ADDENDUM # 2

RFB #: RFB-RC-CP1521-001

Renovation/Construction - Sheriff's Operation Building

A211.00

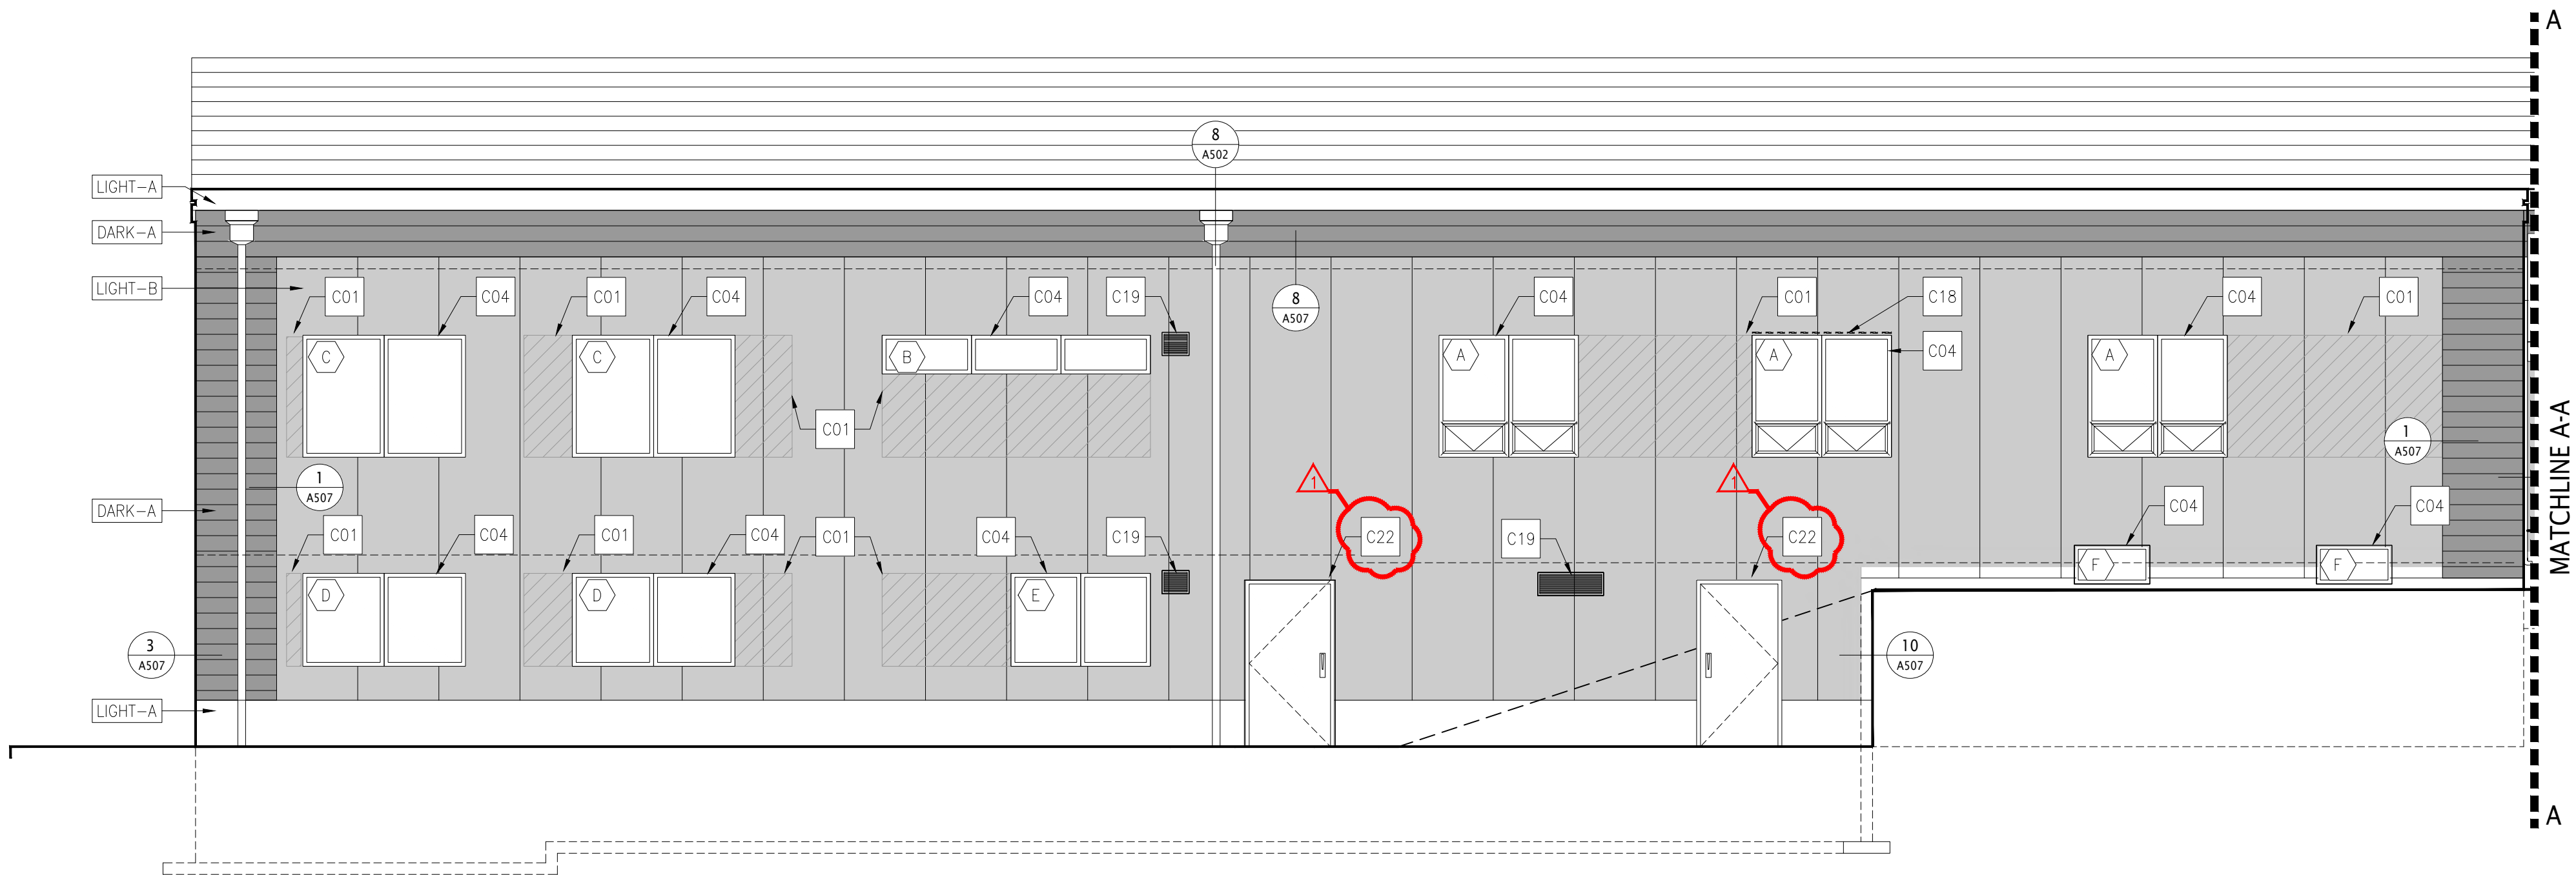
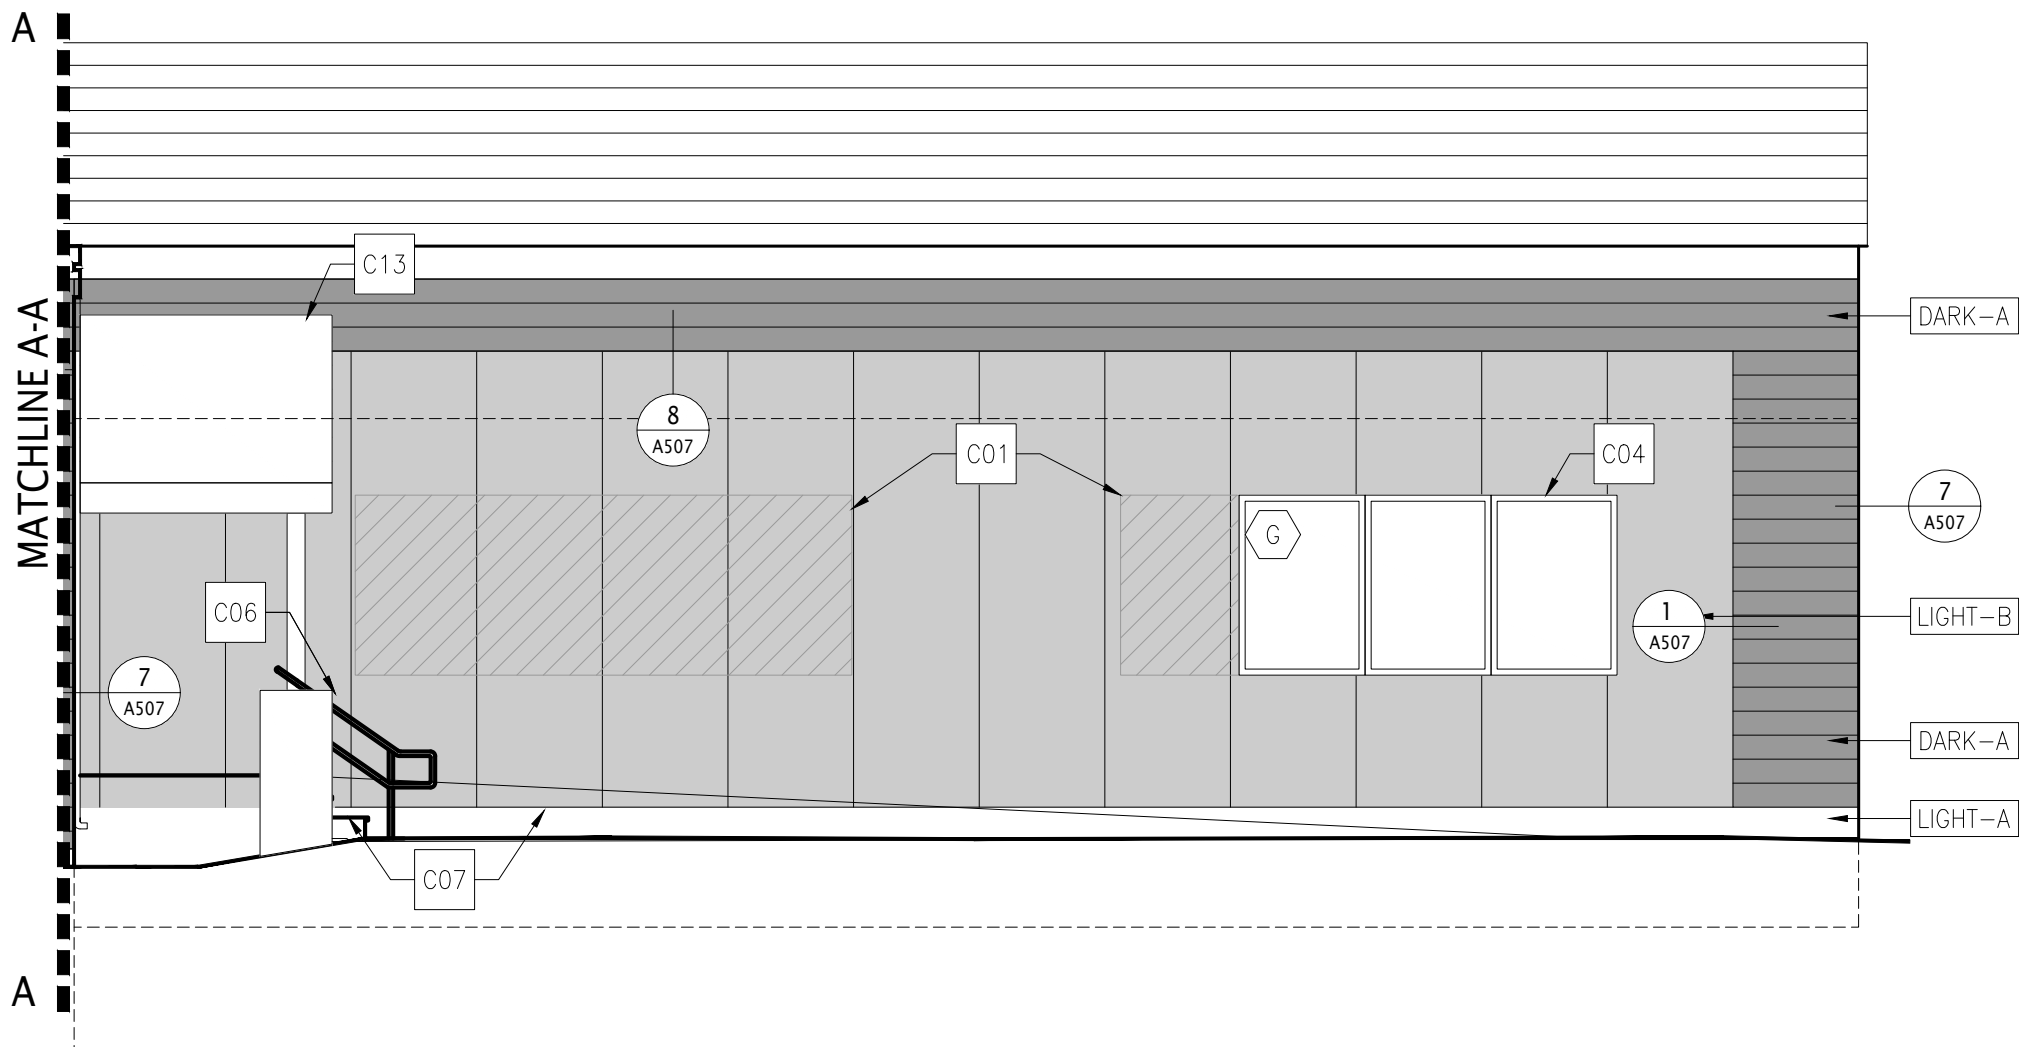
1. Drawing A211 and A214 referring to construction note C05 and point to door elevations. Please clarify if the note should be C18?

Response: *See Addendum Drawings Note C22. "PROVIDE DOOR SYSTEM. REFER TO DOOR SCHEDULE A801" to replace Note C5 of exterior elevations.*

PROJECT NO.:	2616-00	SCALE:	AS NOTED
DRAWING NO.:			
A801.00

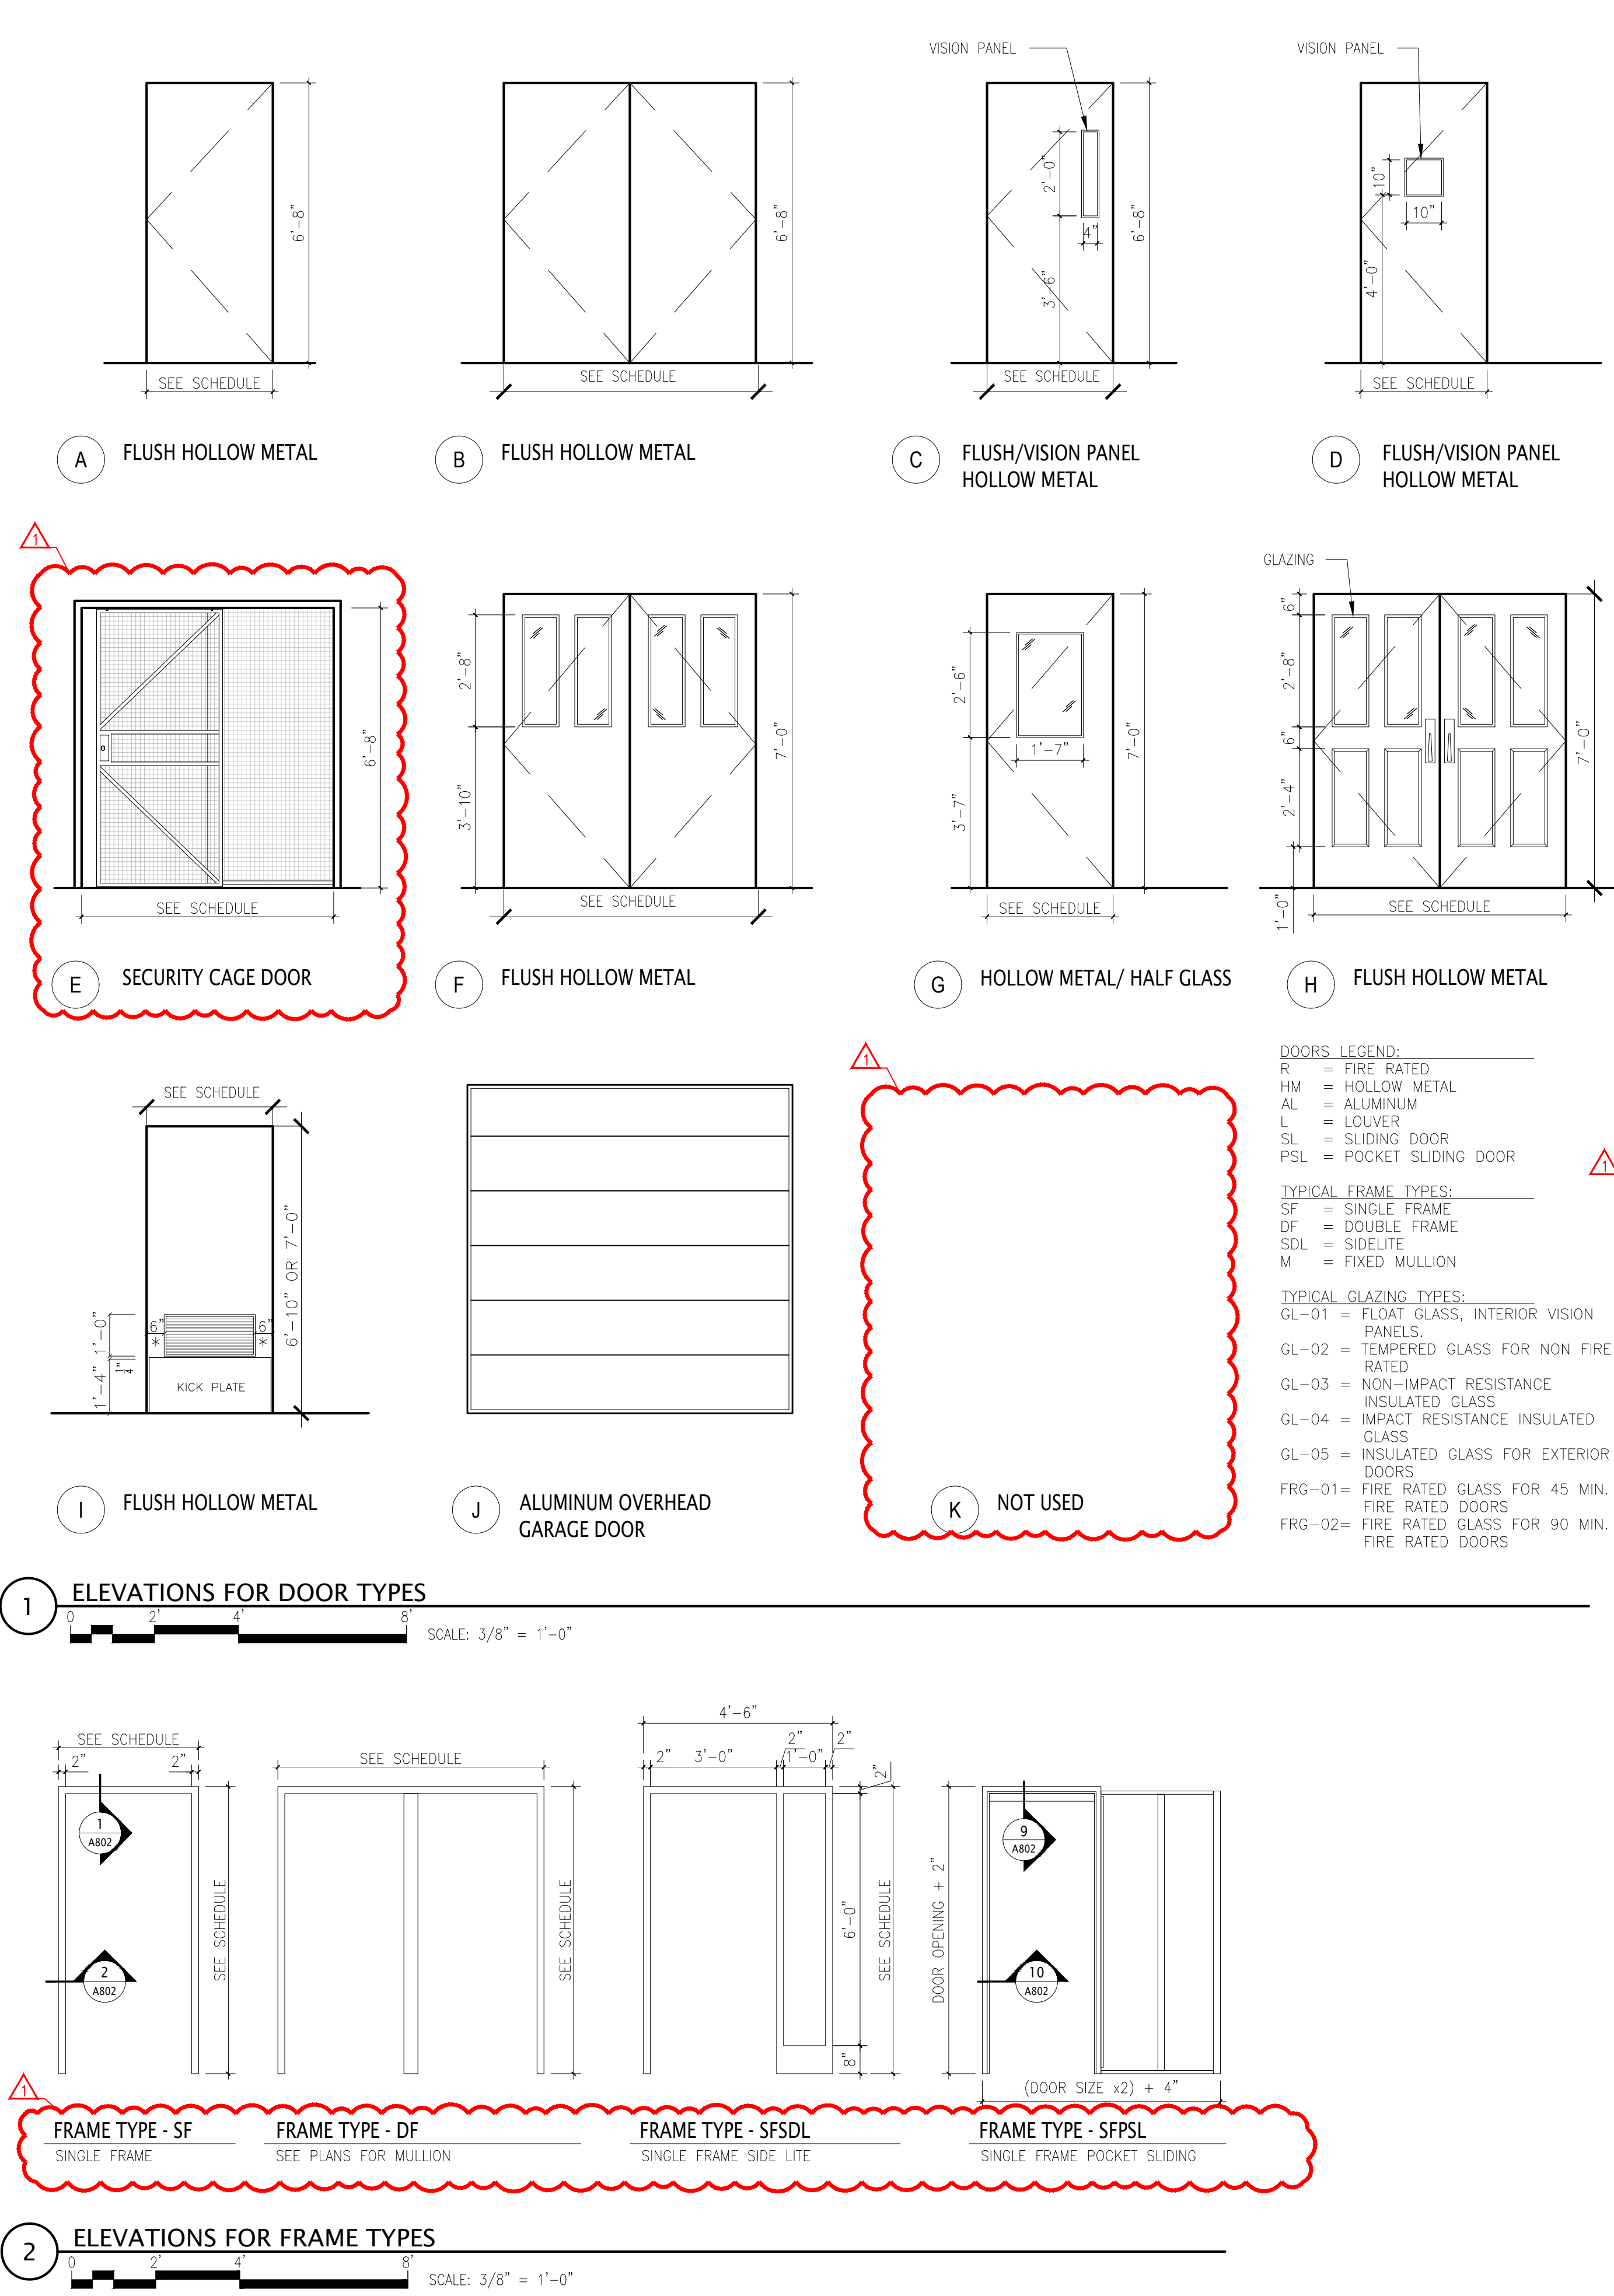
5. Doors 208, 300C, 313A, 315A are noted SFSS frame, which has a sidelight however, no glass type is specified. Please advise.
Response: *No Sidelight for Door 208, 300C, 313A & 315 A. See A801.00
Door 208 & Door 319 is type E. Provide security cage door from securitycaging.com
Door 300C is type C with vision panel. Glass type FRG-02
Door 313 A & 315 A are type A Single frame pocket sliding (SFPSL) for closet.*

6. Door 300C is noted as 90 minute rated, however, the glazing is noted as insulated glass GL-05. Please confirm this is a fire rated insulated unit.
Response: *Door 300C is type C with vision panel. Glass type FRG-02. See A801.00*

7. Door 210 is noted as Type K, and HM/gl, however, the door elevation for Type K notes Aluminum. What is the material for this door? If it is aluminum, what is the specification?

Response: *Door 210 is type A with Sidelight (SFSDL). Glass type GL-02. See A801.00*
8. Glass Type GL-01 is noted at door locations and specified as Annealed. All Door Lites must be tempered and will be quoted as GL-02.

3. Dr A801 Door #208 showing type “A” flush HM. Floor Plan Dr 112 showing sliding door. Please clarify.

Response: *All Vision panels & Sidelights will be GL-02, tempered glass. See A801.00*
9. Sheet A800 specifies ACT#2 ceilings for rooms #106 and 107, but sheet A121 specifies gypsum board. Please confirm whether ACT#2 or gypsum board should be used.

Response: *Room 208 & 319: Provide caging doors from Security caging. See A801 for elevation.*
